309 KING STREET NEWCASTLE

COUNCIL RFI - SOLAR

25 JUNE 2025

CONTENTS
SOLAR ACCESS COMPLIANCE RESPONSE

REV. 13
DRAWING NO. DA516

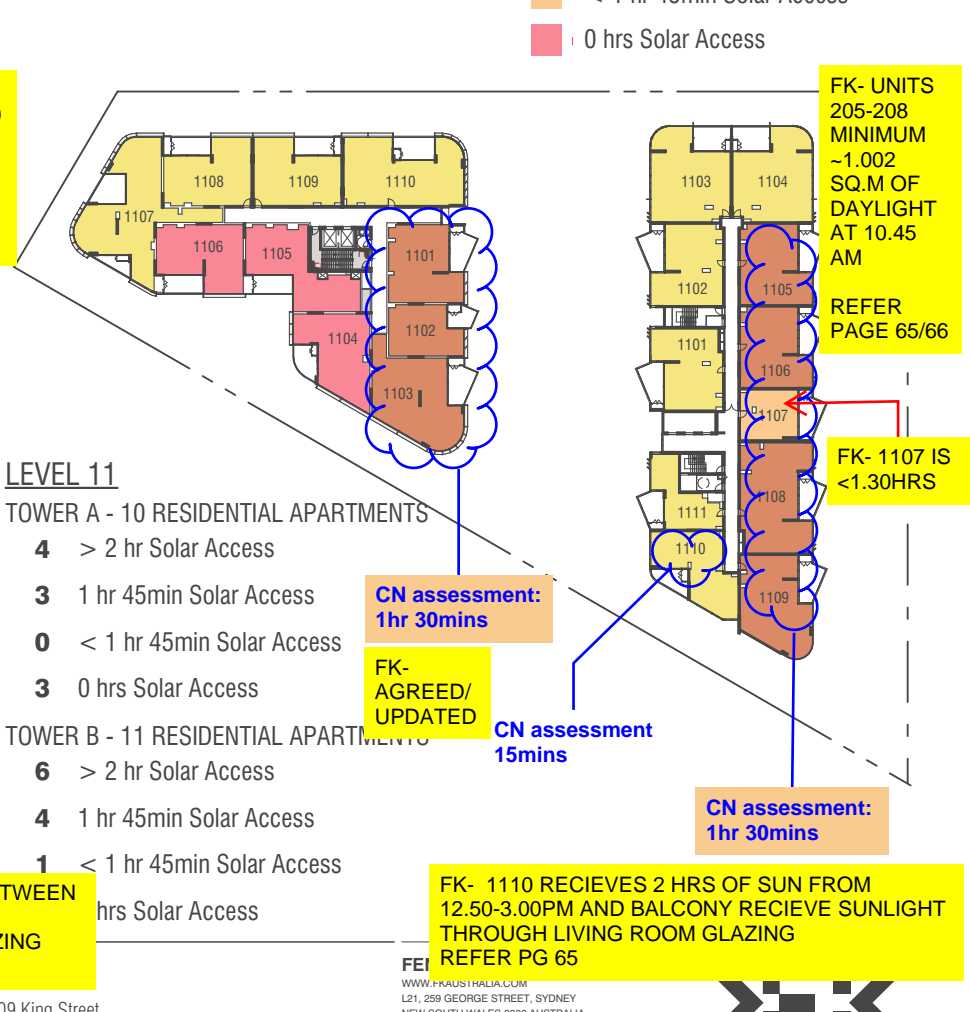
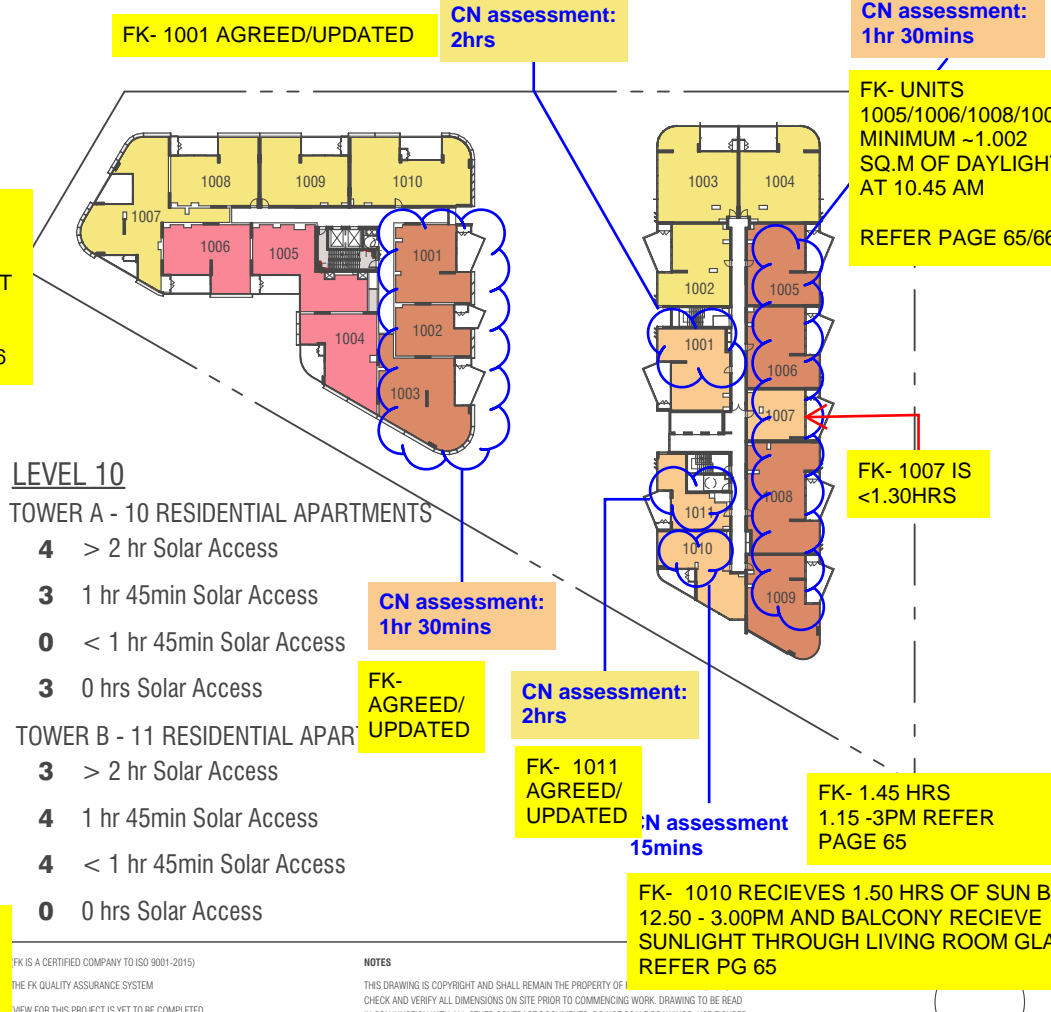
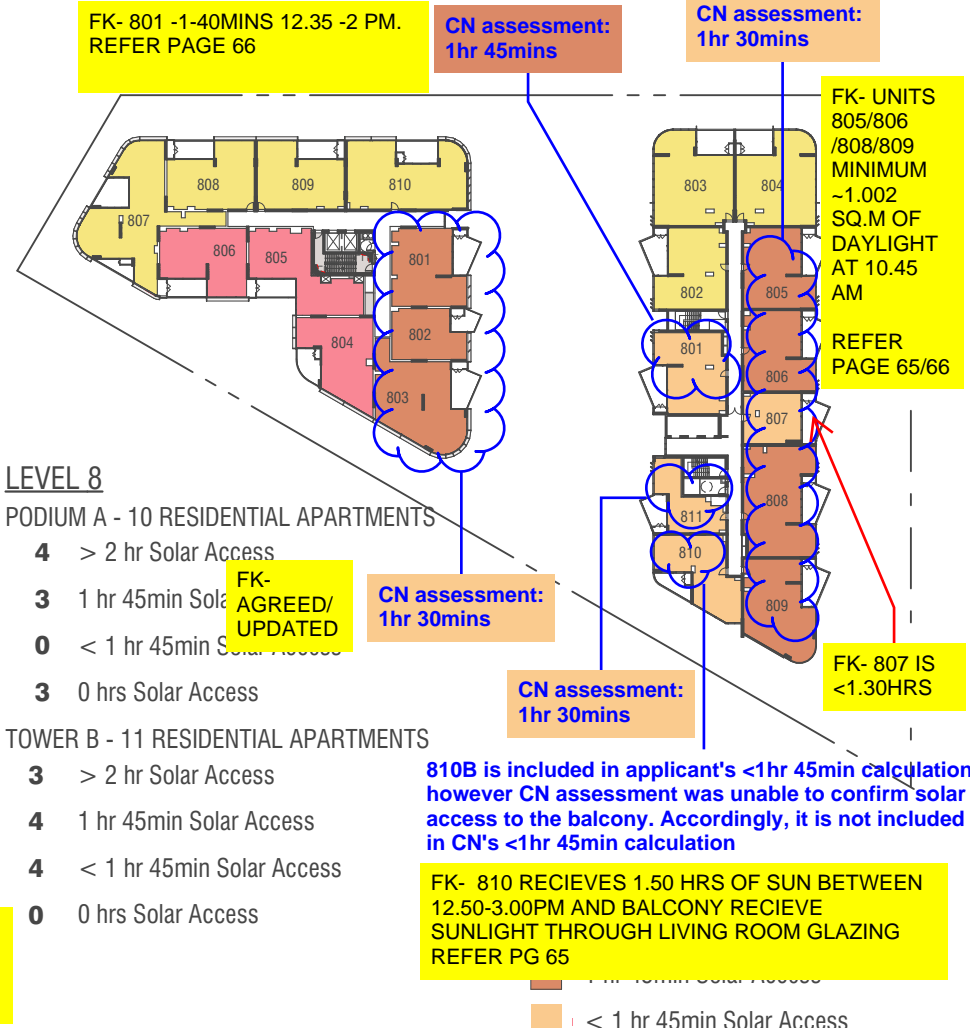
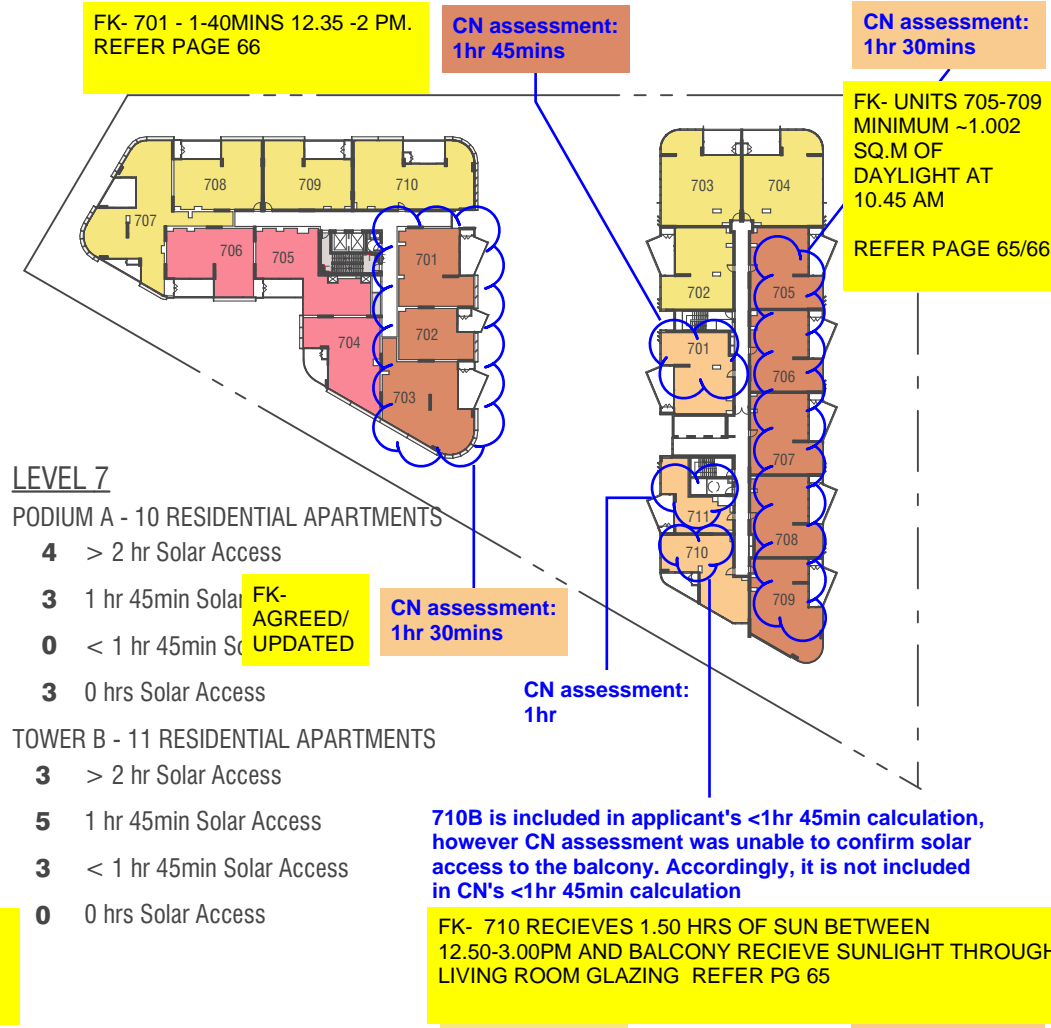
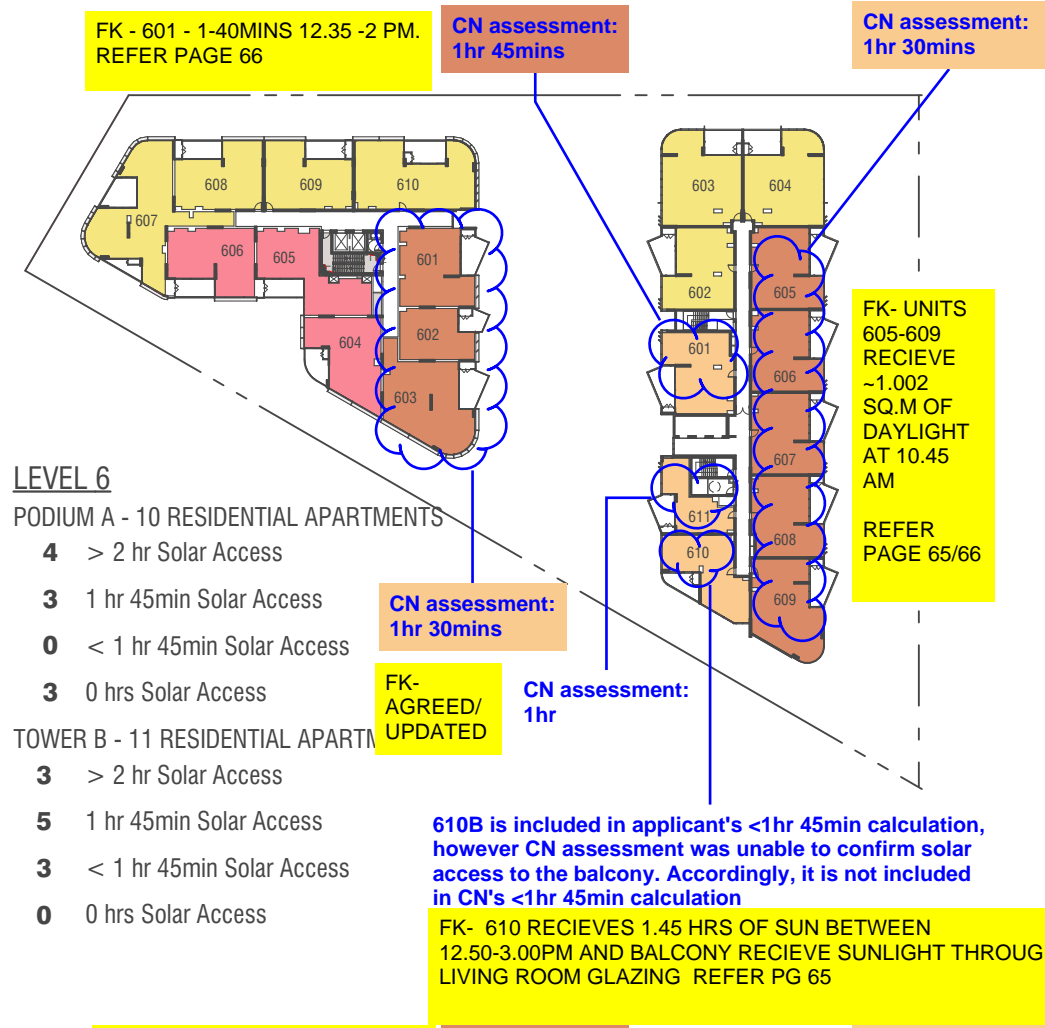
203A is included in applicant's 1hr 45min calculation, however CN assessment was unable to confirm solar access to the living room. Accordingly, it is not included in CN's 1hr 45min calculation

201A and 202A are included in applicant's < 1hr 45min calculation, however CN assessment was unable to confirm solar access to the living rooms due to awning structure over. Accordingly, they are not included in CN's < 1hr 45min calculation

CN assessment: 1hr 30mins

CN assessment: 45mins

CN assessment: 1hr

CN assessment: 1hr 45mins

410B is included in applicant's <1hr 45min calculation, however CN assessment was unable to confirm solar access to the balcony. Accordingly, it is not included in CN's <1hr 45min calculation

FK- AGREED - 203A UPDATED TO <1.30 REFER MOD 2 SOLAR ACCESS DIAGRAMS

FK- AGREED - 201A/202 A RECIEVE 15 MINS BETWEEN 9 AM -10 AM

FK- AGREED

FK- UNITS 205-208 MINIMUM ~1.002 SQ.M OF DAYLIGHT T AT 10.45 AM REFER PAGE 65

FK- ALREADY IDENTIFIED IN THEIR DOCUMENTATION

FK- 1-40MINS REFER PAGE 66

FK- AGREED/UPDATED

FK- BALCONY RECIEVE 1.30HRS REFER SOLAR ACCESS DIAGRAMS REFER PAGE 64

REV.	DRAWING NO.
14	DA518

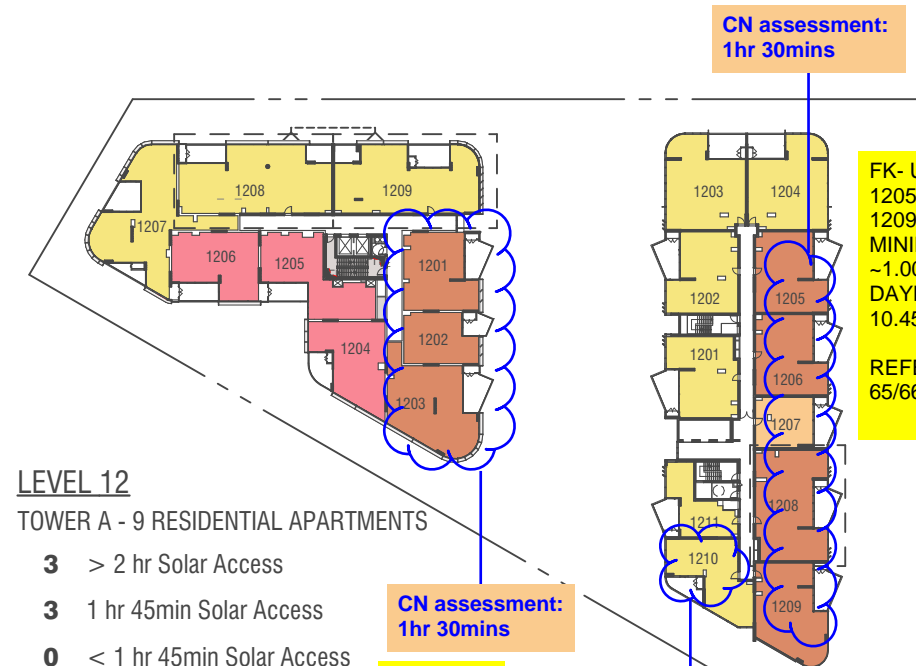
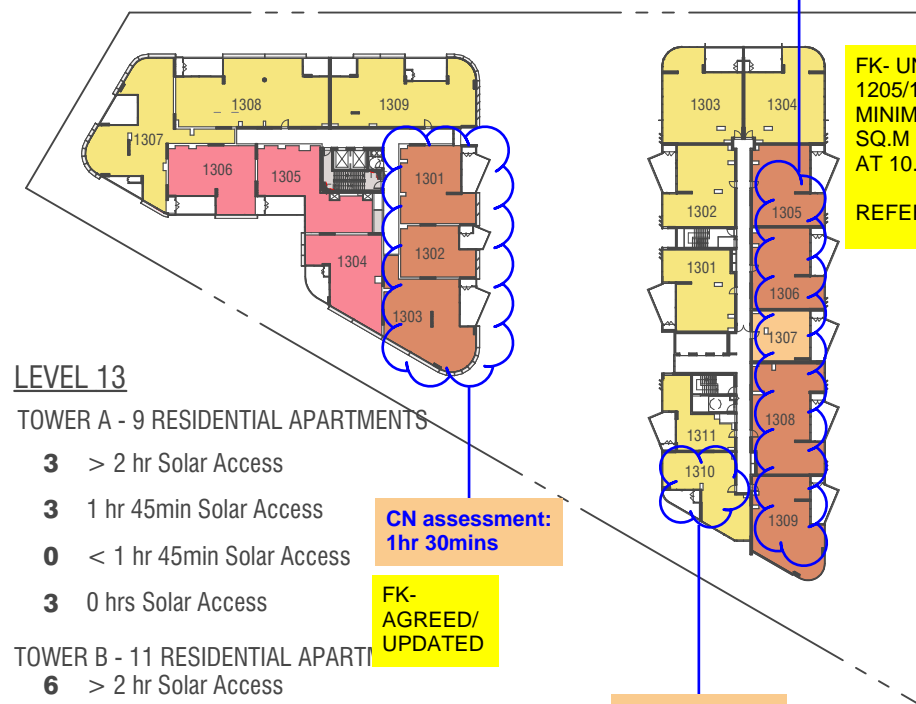
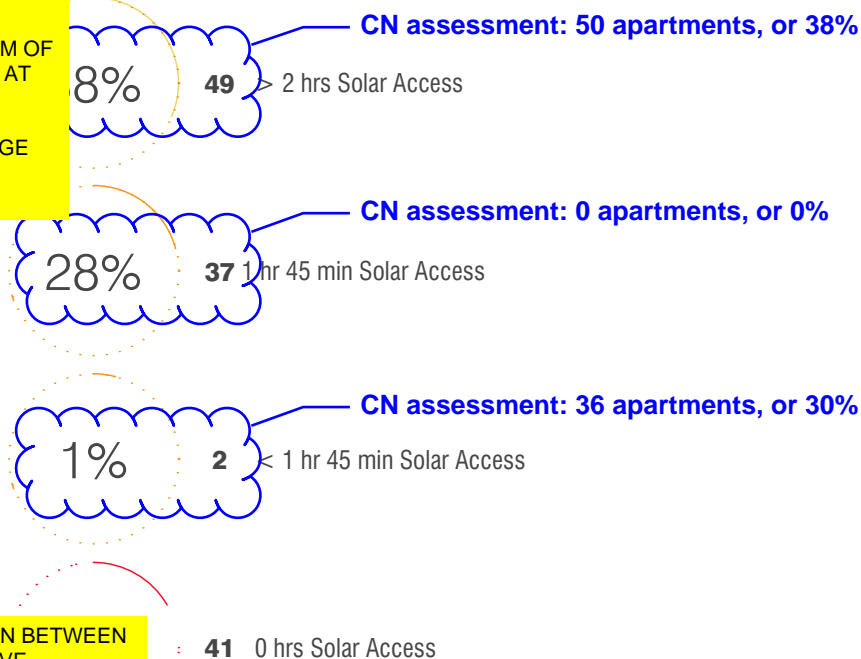
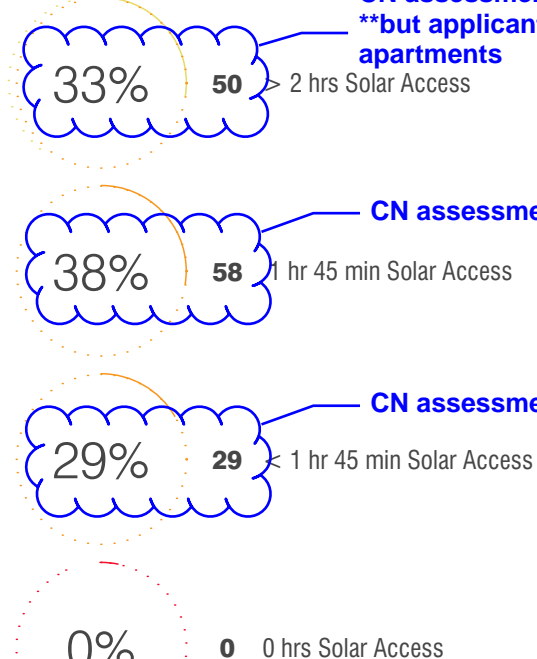
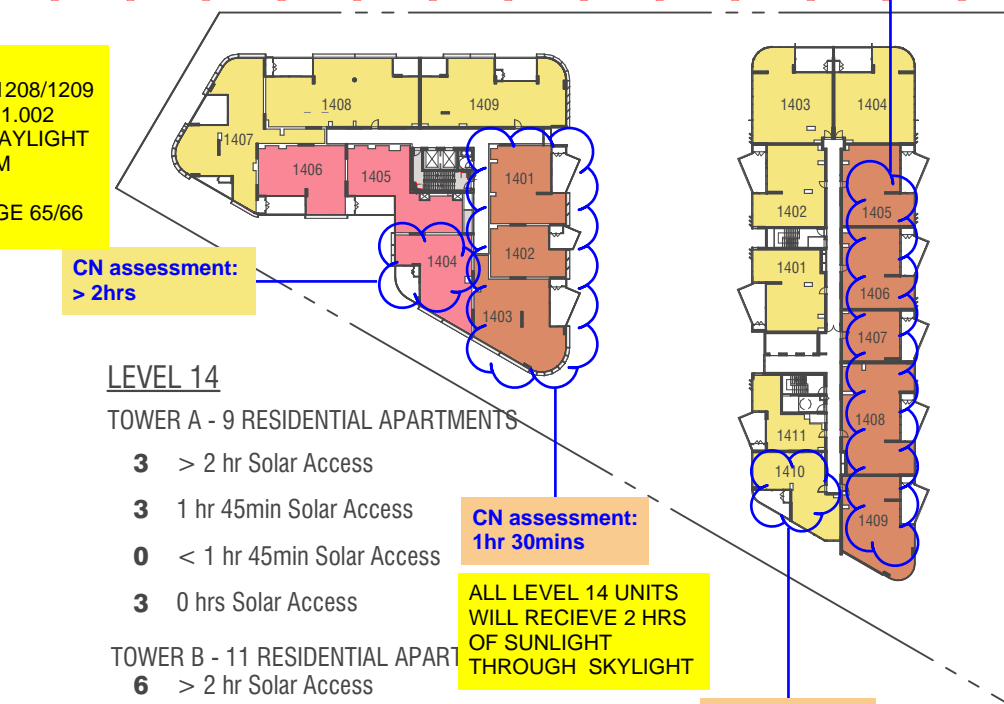
CN assessment: 50 apartments, or 33%
**but applicant and CN have included different
apartments

FK- 1310 RECIEVES 2.00 HRS OF SUN BETWEEN 12.50 - 3.00PM AND BALCONY RECIEVE SUNLIGHT THROUGH LIVING ROOM GLAZING REFER PG 65

FK- 1310 RECIEVES 2.00 HRS OF SUN BETWEEN 12.50 - 3.00PM AND BALCONY RECIEVE SUNLIGHT THROUGH LIVING ROOM GLAZING REFER PG 65

FK- SUMMARY UPDATED
REFER TO PG 19 -PART 1

FK- UNITS
1205/1206/1208/
1209
MINIMUM
~1.002 SQ.M OF
DAYLIGHT AT
10.45 AM

ALL LEVEL 14 UNITS
WILL RECIEVE 2 HRS
OF SUNLIGHT
THROUGH SKYLIGHT

APARTMENT TYPOLOGY SOLAR ANALYSIS - TOWER B UNIT 505 - 1HR.45MIN

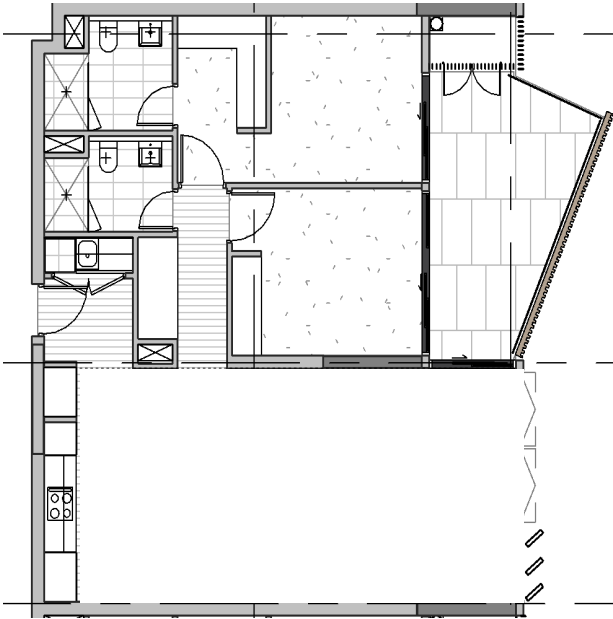
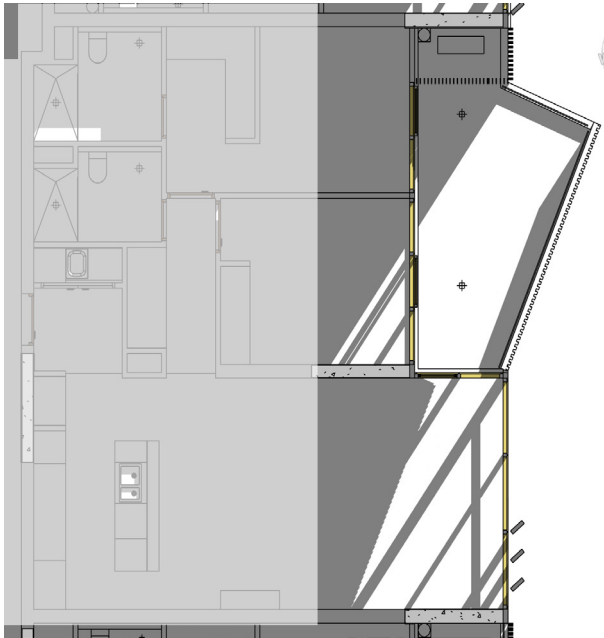
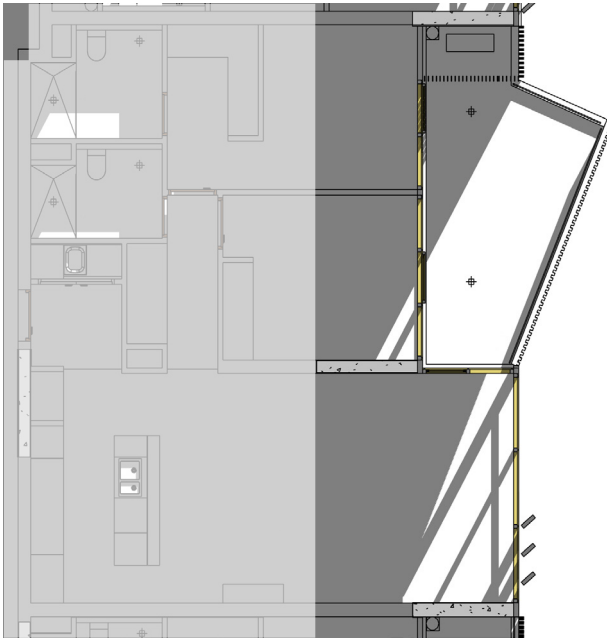
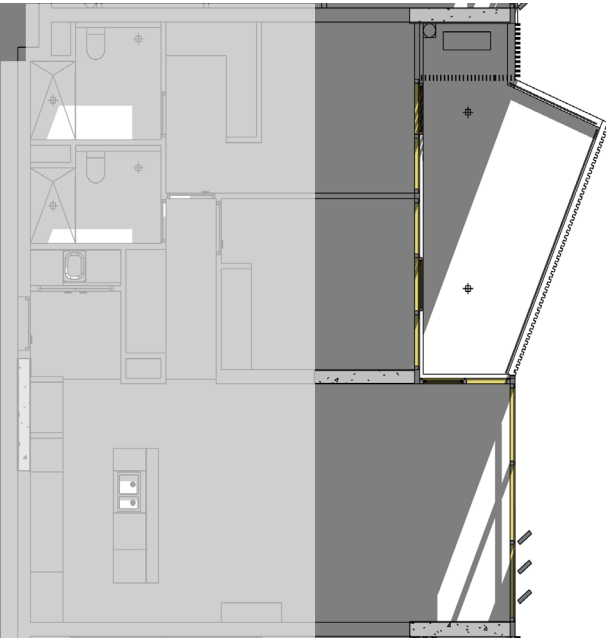
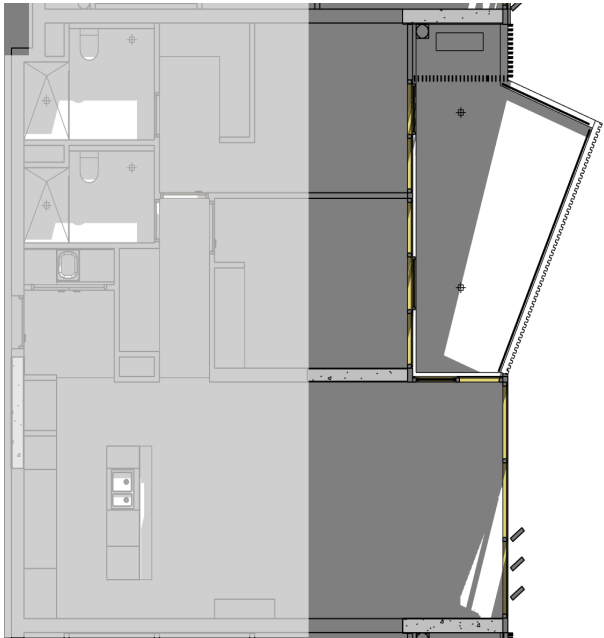
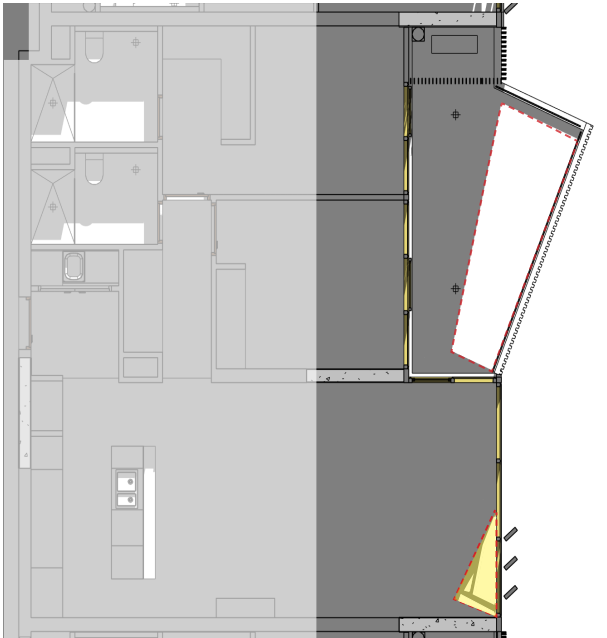
COUNCIL COMMENT - LEVEL 2-14 - CN ASSESSMENT: 1HR 30MINS

AT 10.45 AM UNIT RECIEVES 1.002 SQ,M OF DAYLIGHT

DAYLIGHT ANALYSIS -10.45 AM
LIVING ROOM -1.002SQ.M
BALCONY - 6.345SQ M

APARTMENT TYPOLOGY SOLAR ANALYSIS - TOWER B UNIT 509 - 1HR.45MIN

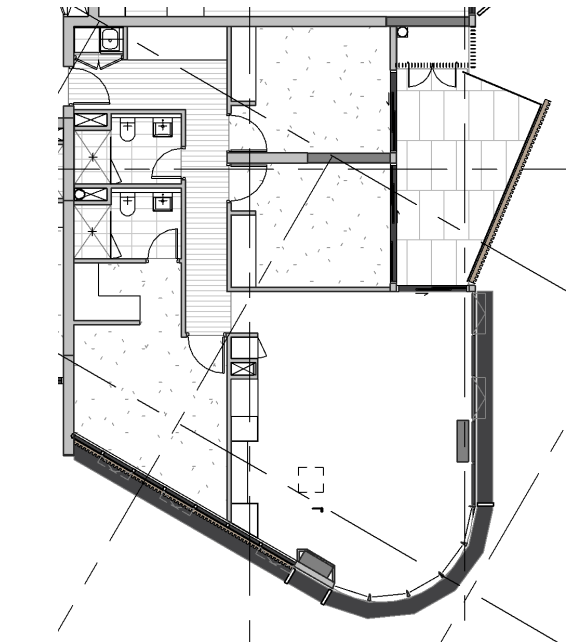
COUNCIL COMMENTS - LEVEL 2-14 - CN ASSESSMENT: 1HR 30MINS

AT 10.45 AM UNIT RECIEVES 1.06 SQ,M OF DAYLIGHT

DAYLIGHT ANALYSIS -10.45 AM
LIVING ROOM - 1.06 SQ.M
BALCONY - 6.345SQ M
